# 1ST & PIKE

103 PIKE STREET

EARLY DESIGN GUIDANCE 3  
03 APRIL 2018  
DPD #3028428

## 1. PODIUM - BUILDING CORNERS

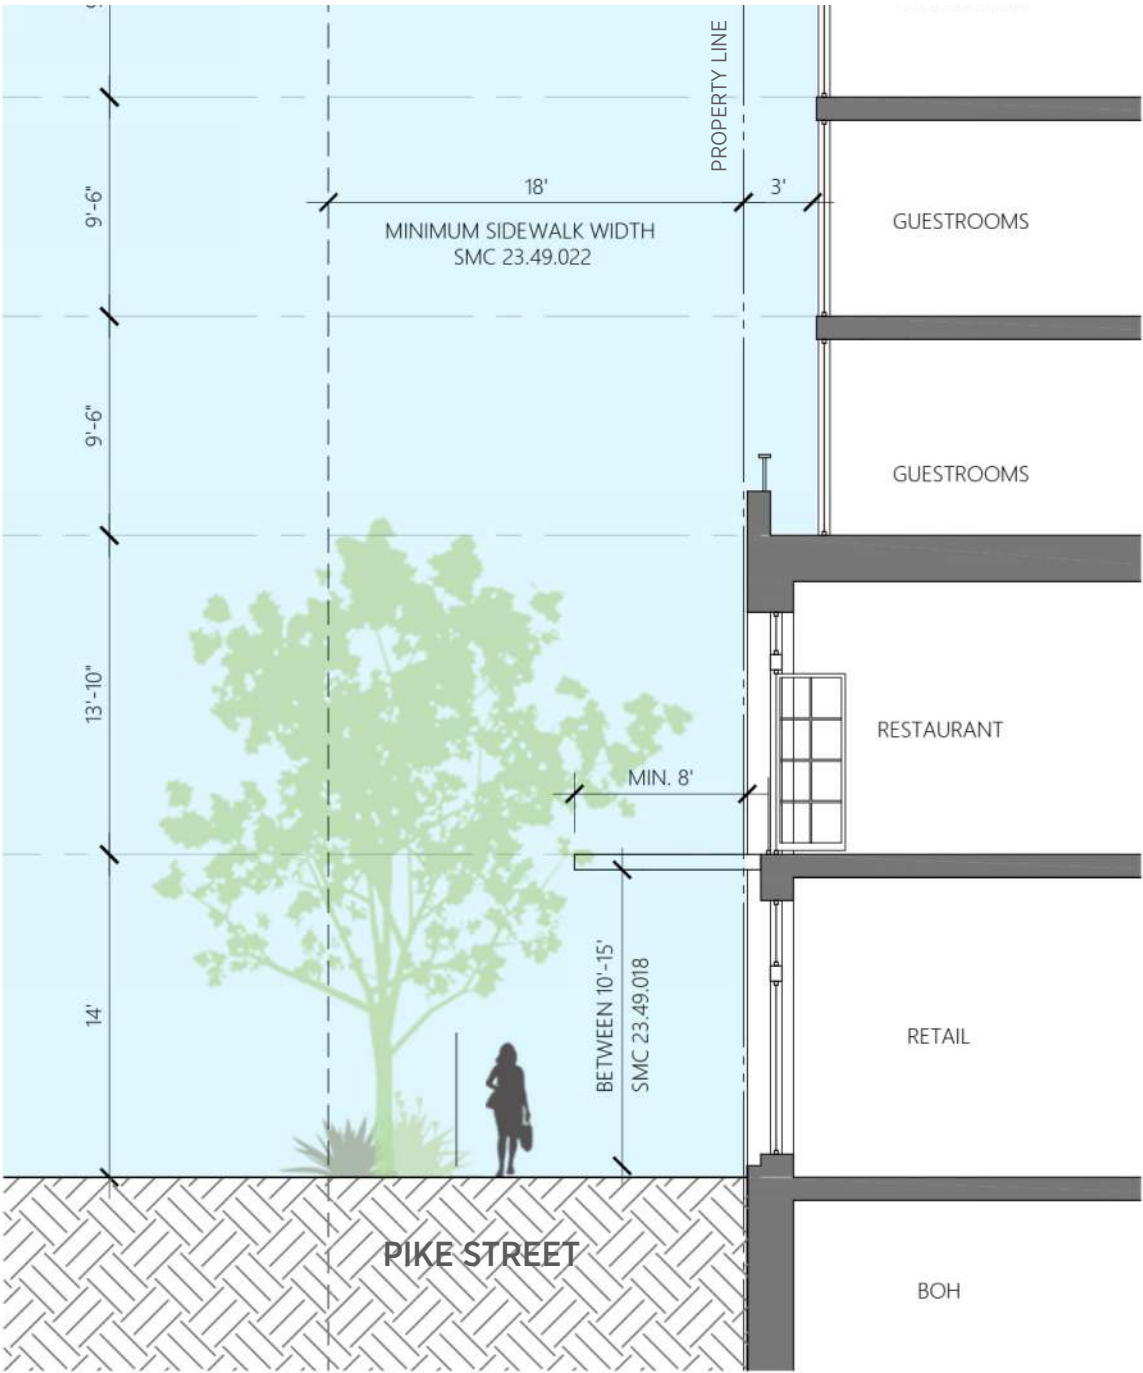
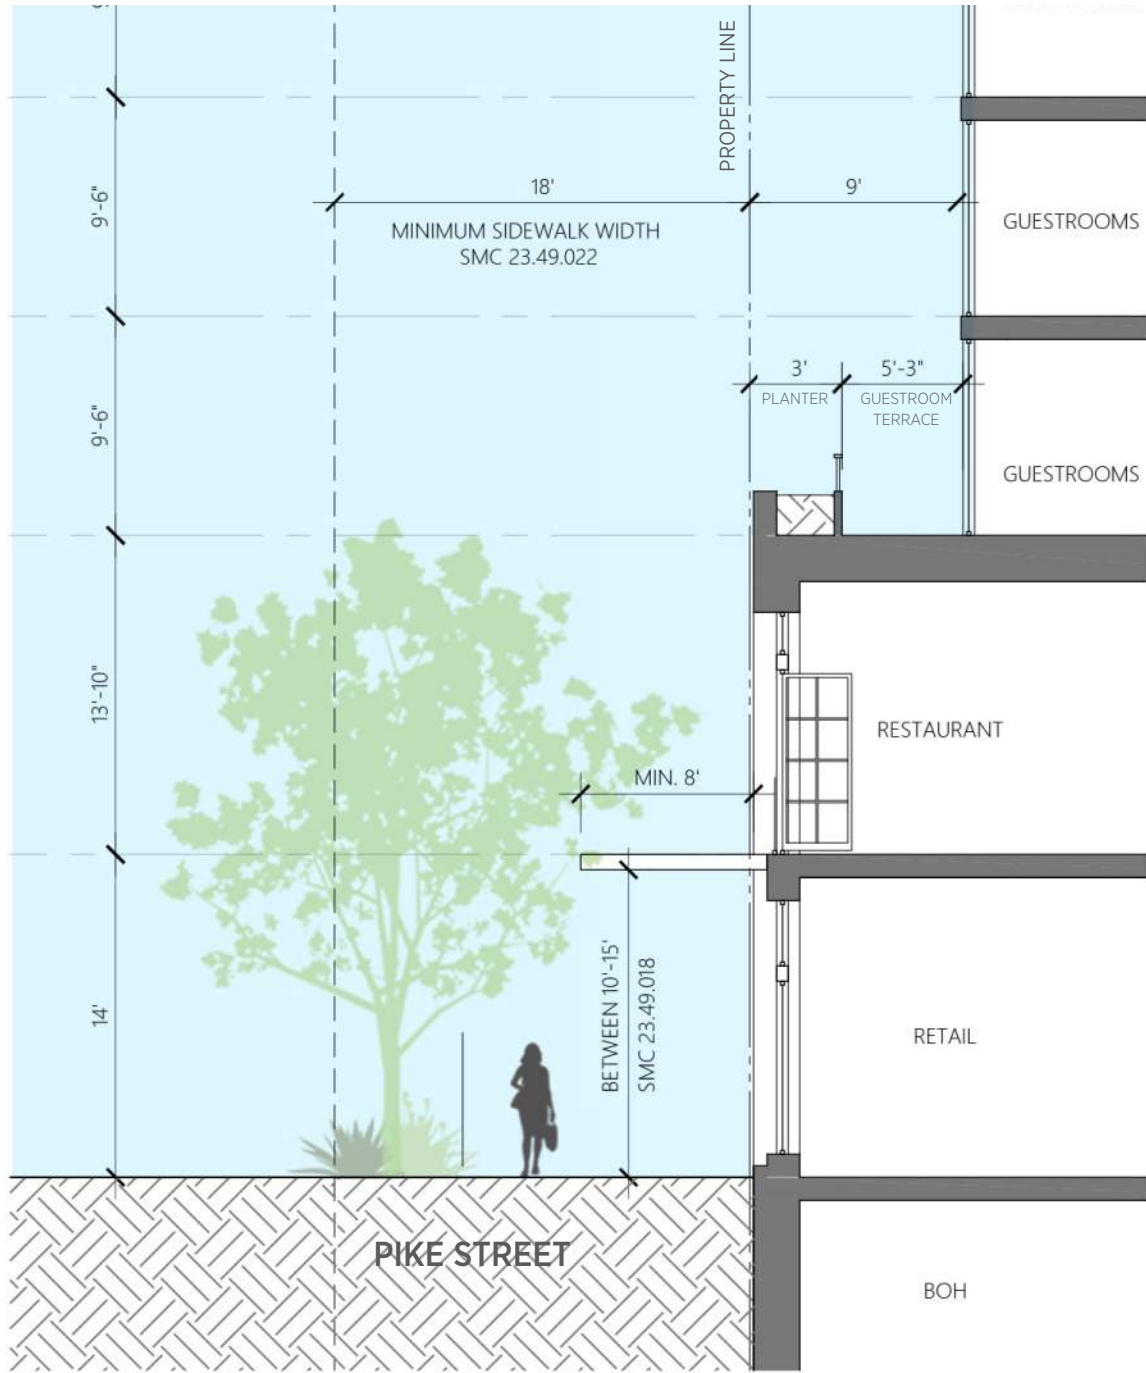
*1.a.ii. The Board stated that as the podium wraps into the alley, there should be further articulation of the materials. Also, all edge transitions at building corners and where the podium and tower interact should be carefully considered.*

The design team has studied material transitions at the corners:

- At the podium the brick wraps the entire except where the feature wall extends to the ground on the South facade.
- On the tower, the pattern from the window wall continues on all sides, with solid panel replacing vision glass on the South and East Facades.

1. PODIUM - CANOPIES

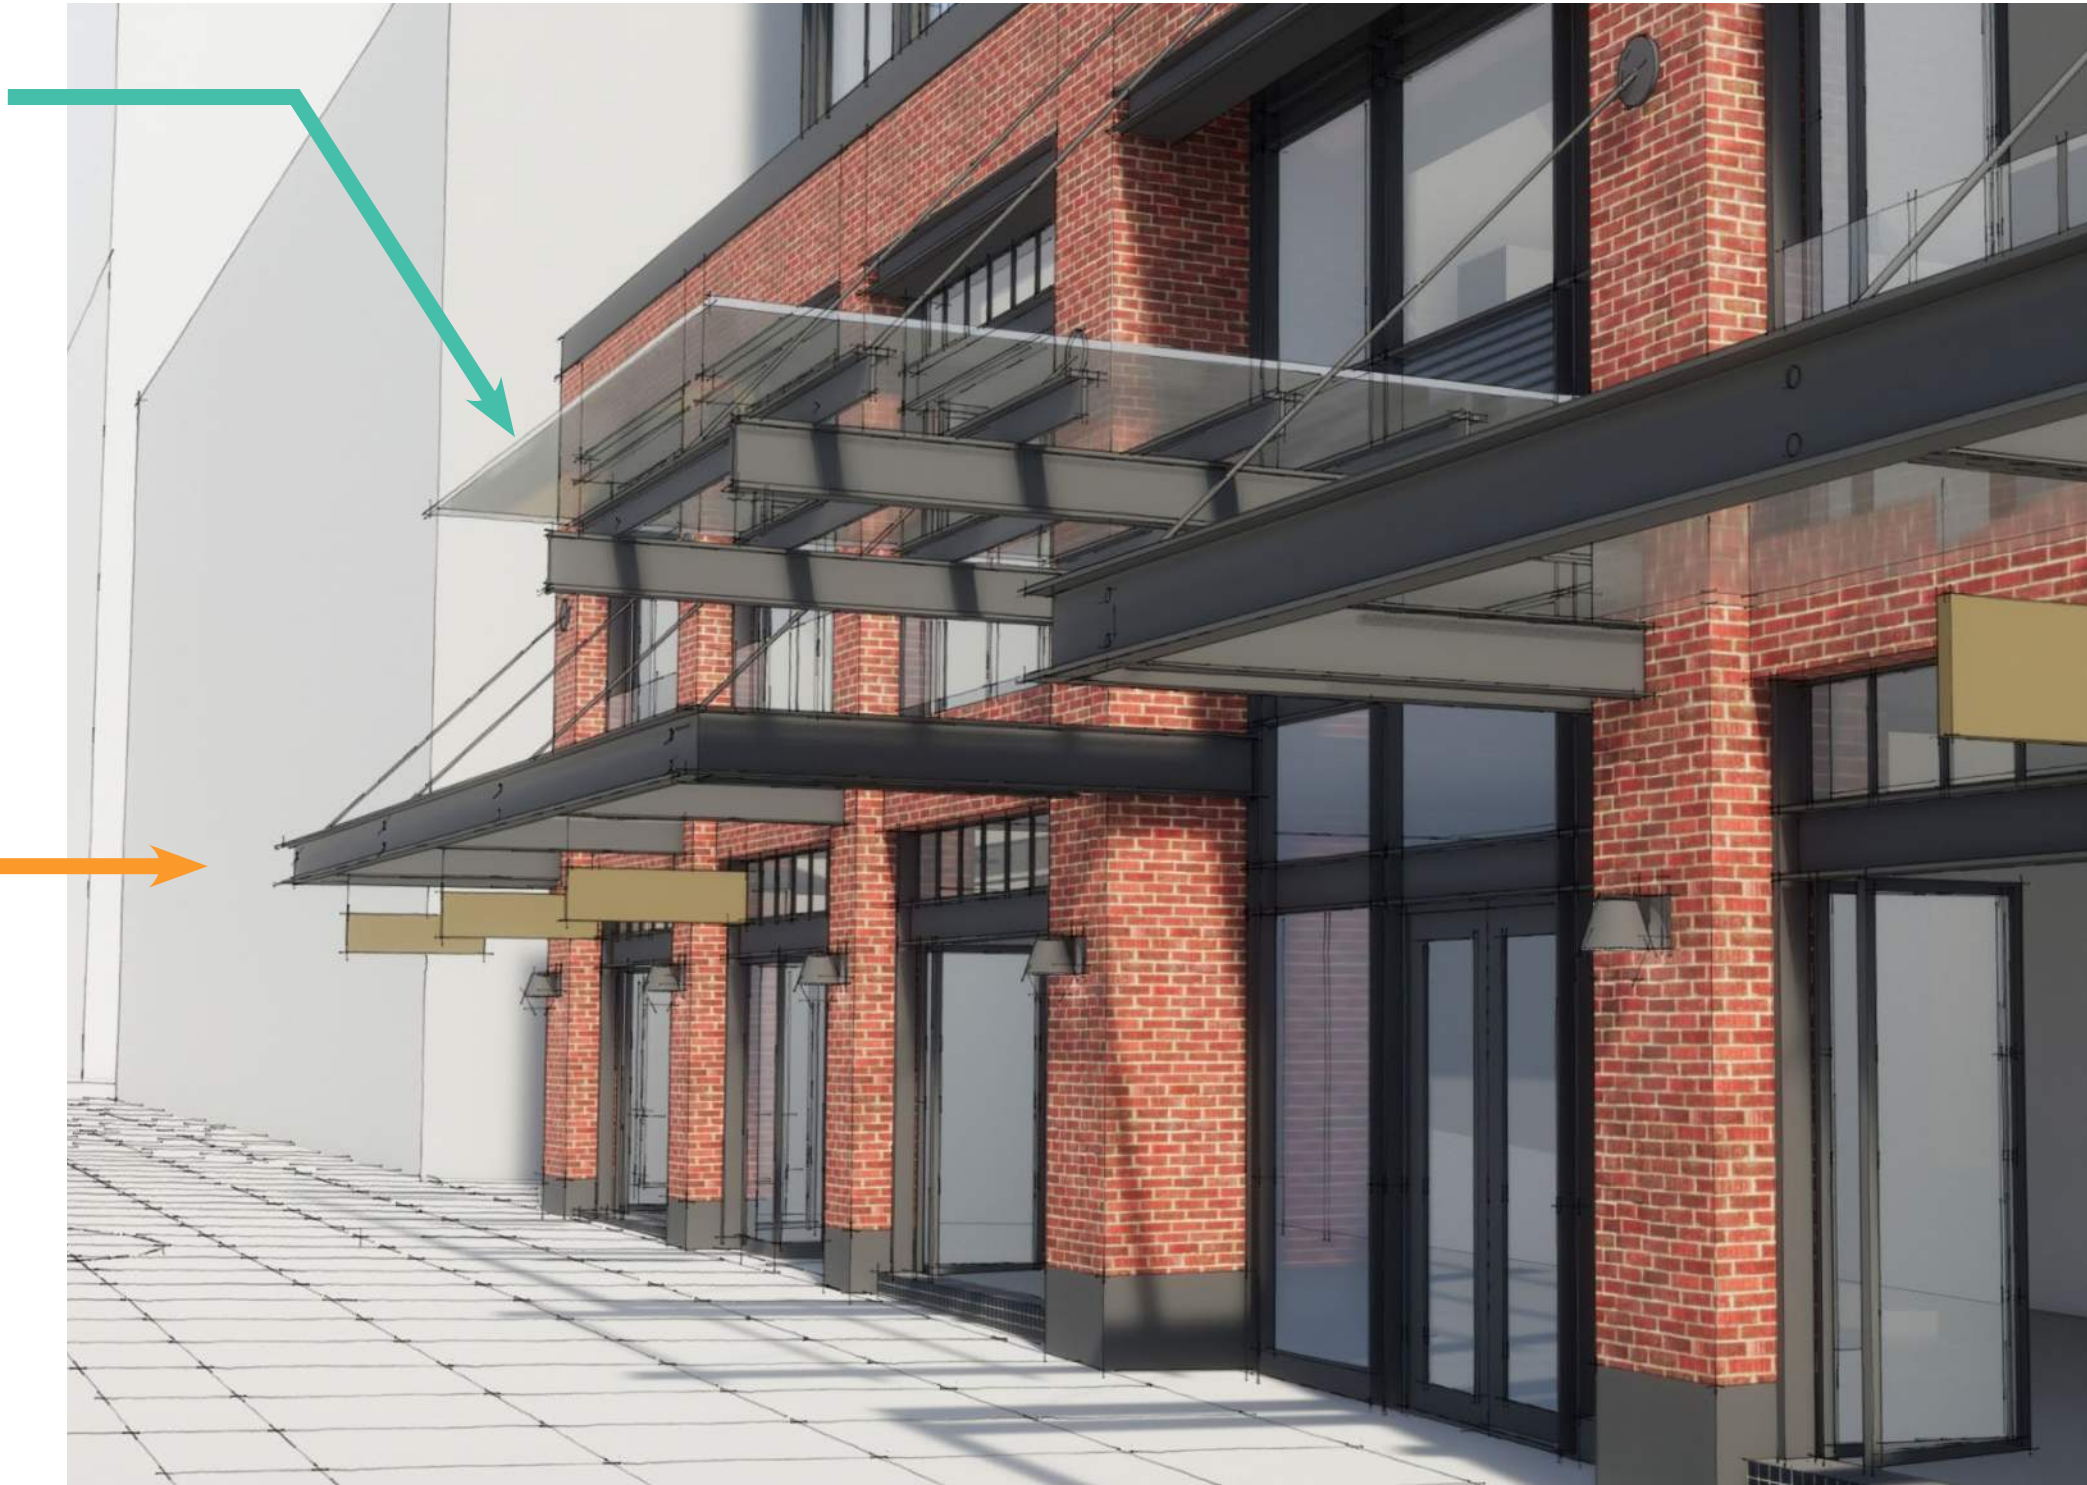
- The Board advised that the design’s podium canopies, especially the hotel entry canopy, will be closely examined in terms of their scale and articulation and how they relate to other canopies in the neighborhood.

Two canopy types are proposed:  
A simple canopy with a C-channel edge detail for the retail, and a lighter glass and exposed structure canopy for the hotel.

Having a different canopy for the hotel will distinguish it as the main building entry.
